VINEYARD ESTATES V  
(4-21-03; 2003C-109)

CARMEL RIDGE SUBDIVISION  
BEING A REPLAT OF LOT 29, BLOCK 3, UNIT 3, TRACT 2, NAA  
GRADING & DRAINAGE PLAN

SHEET 1 OF 1

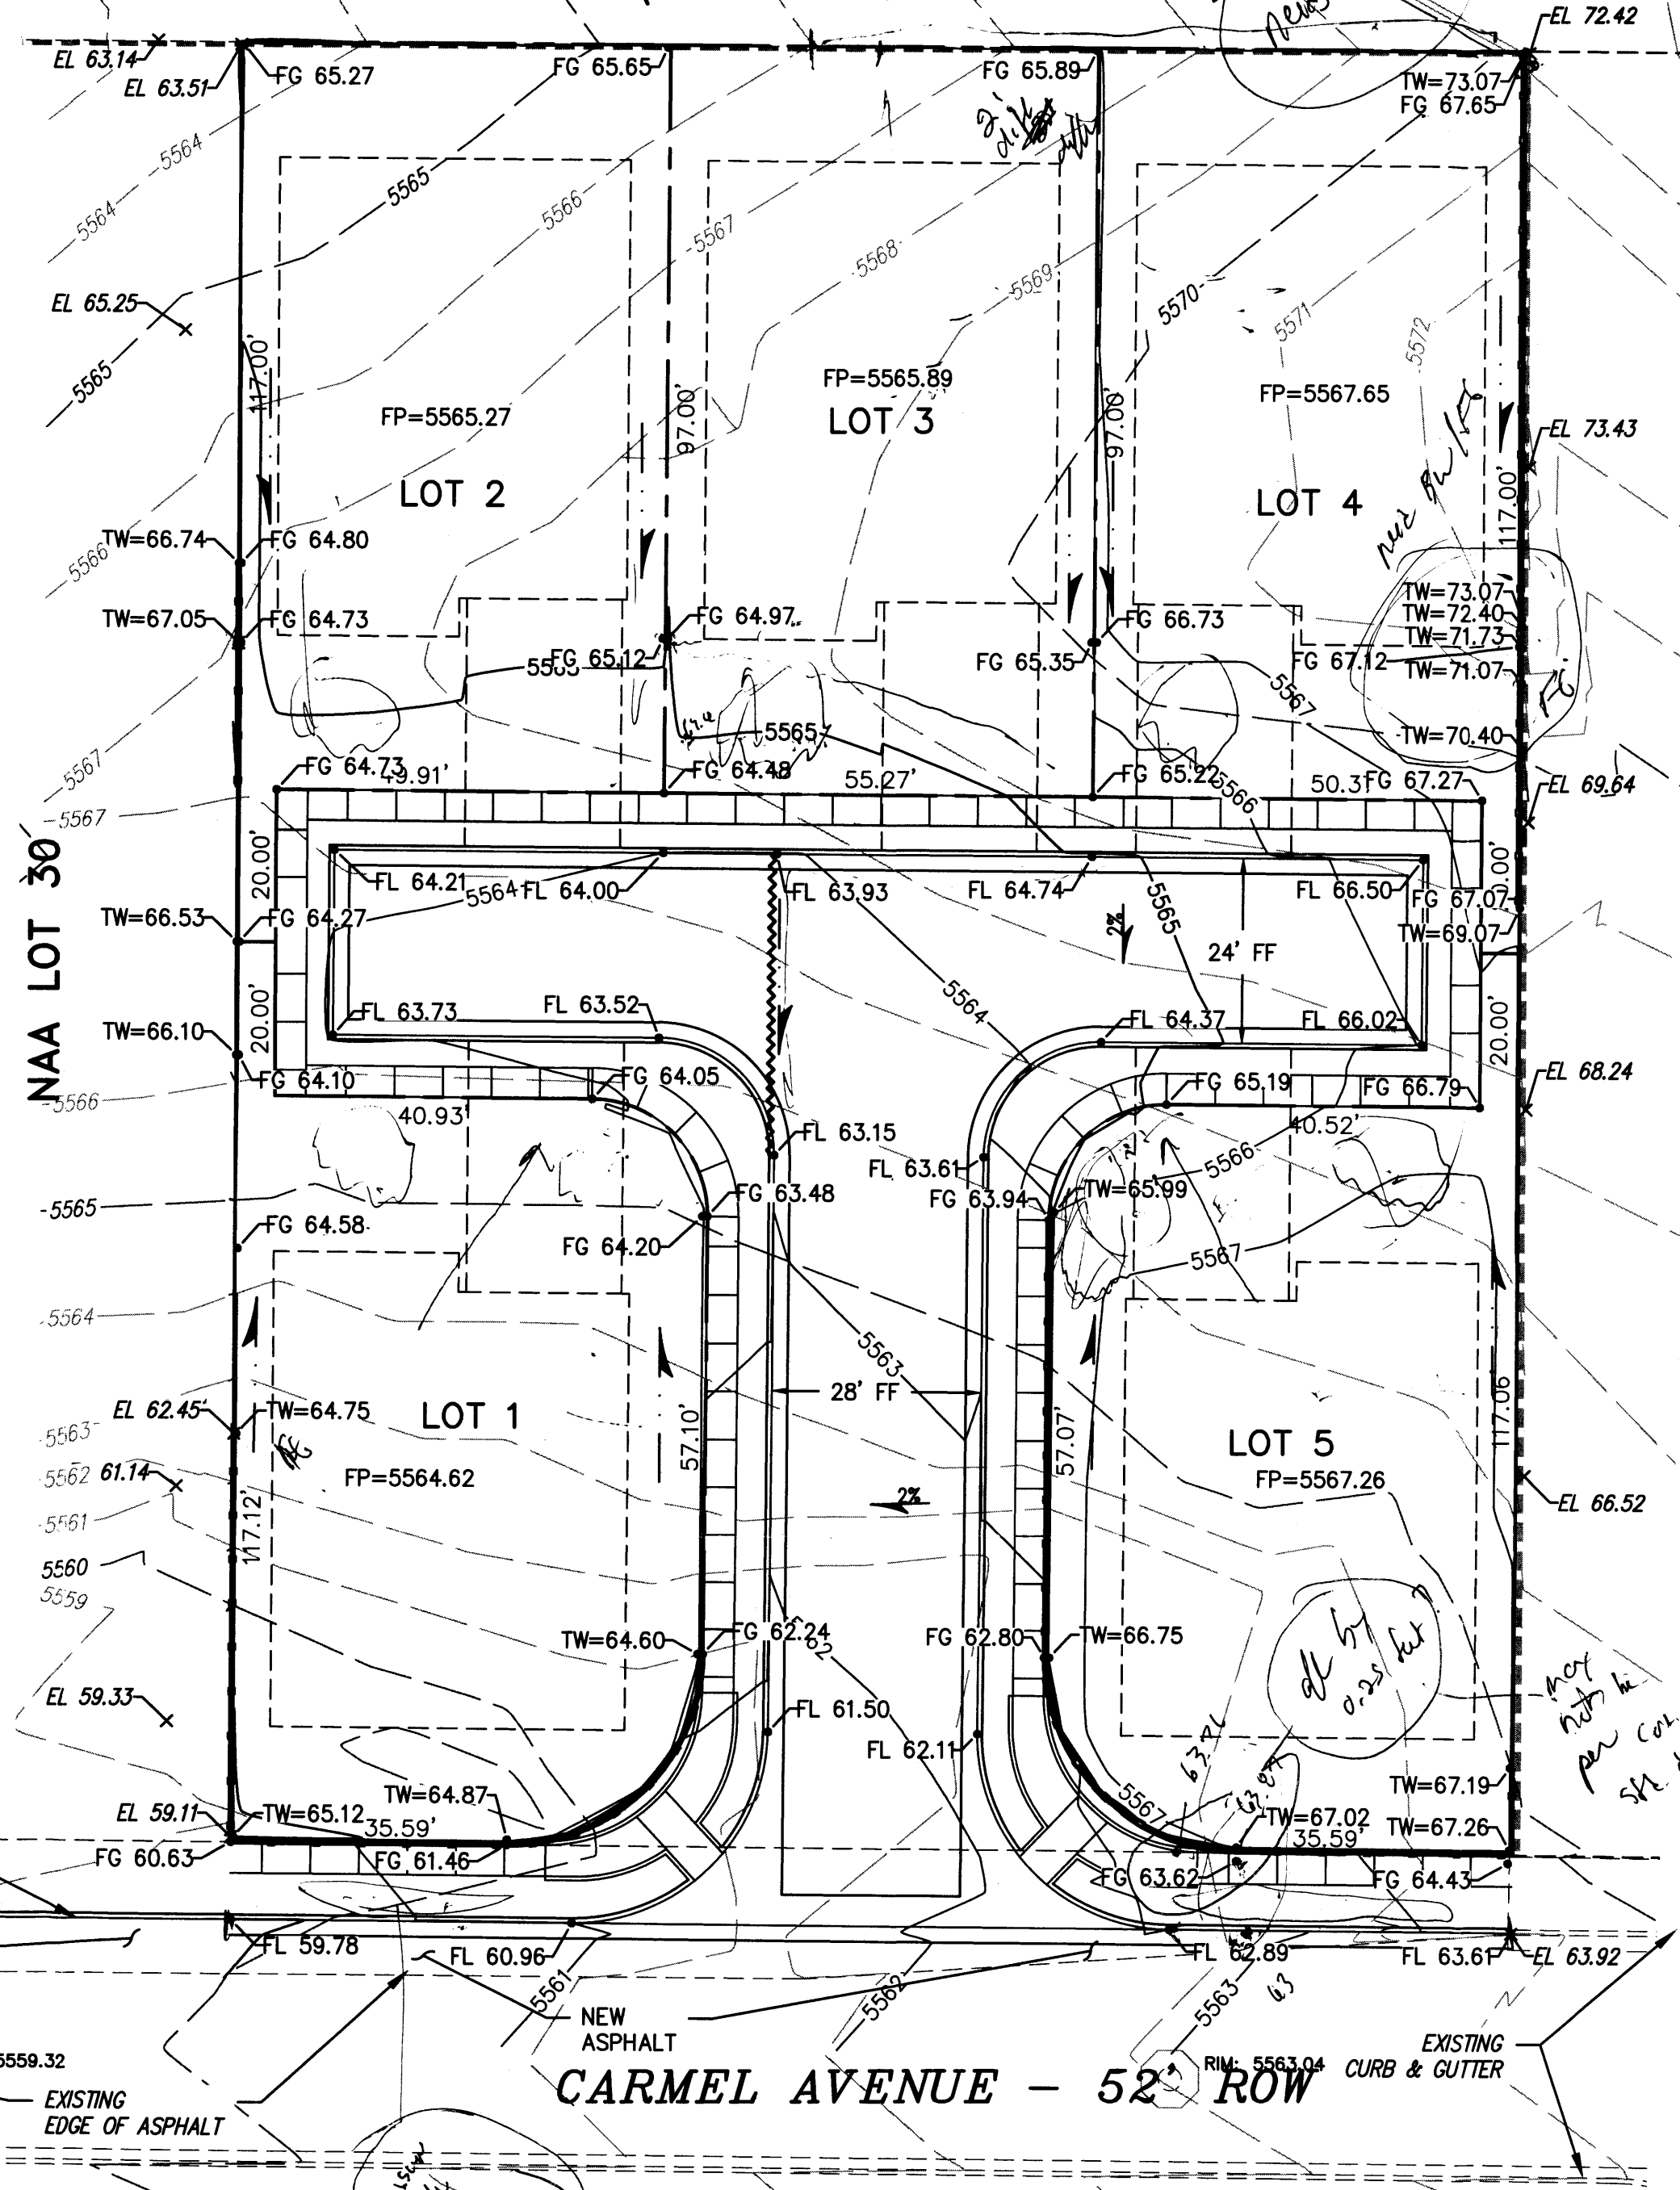
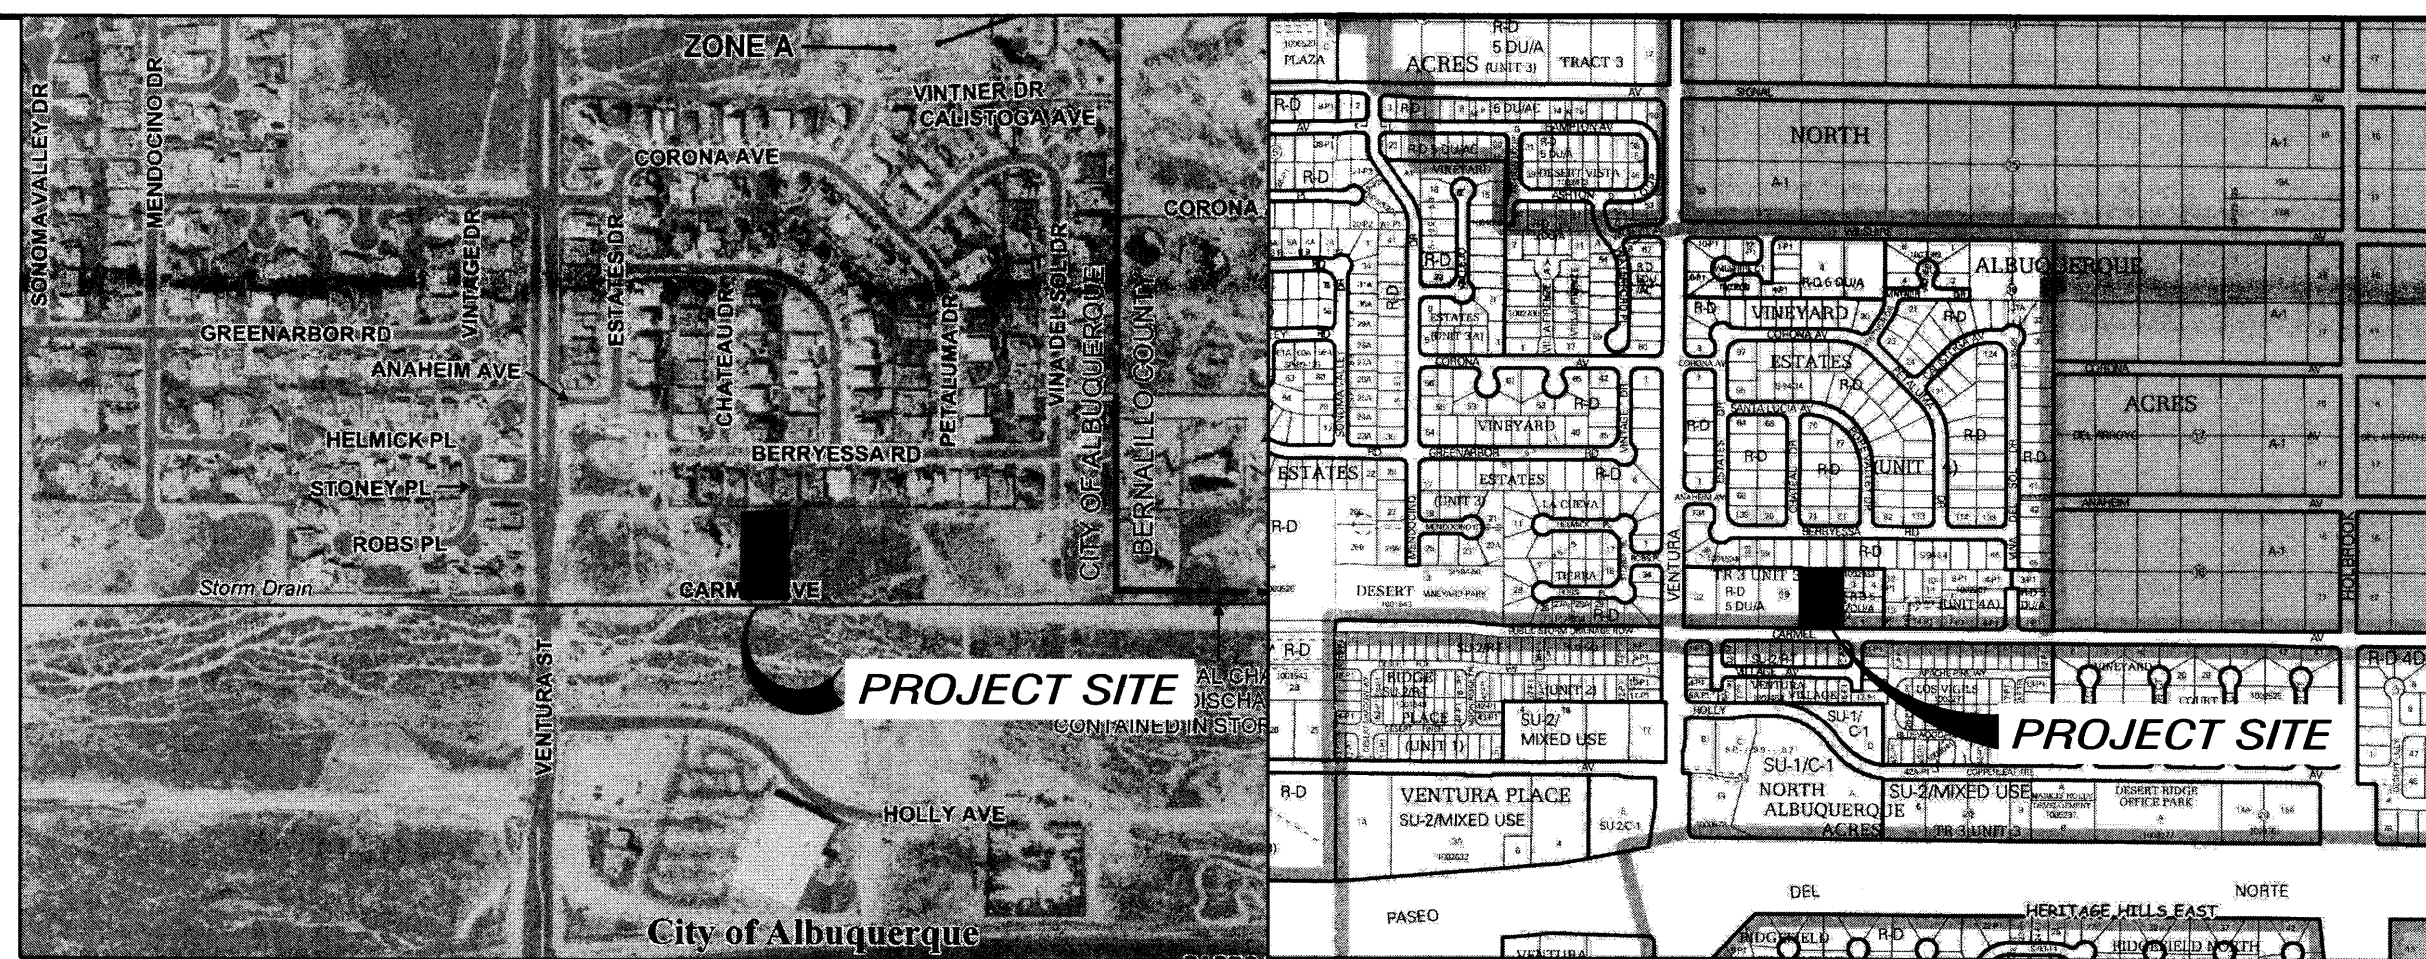
When showing our grading permit  
please address the following  
Comments:  
- Mmm for P.P.  
- Comments & grading
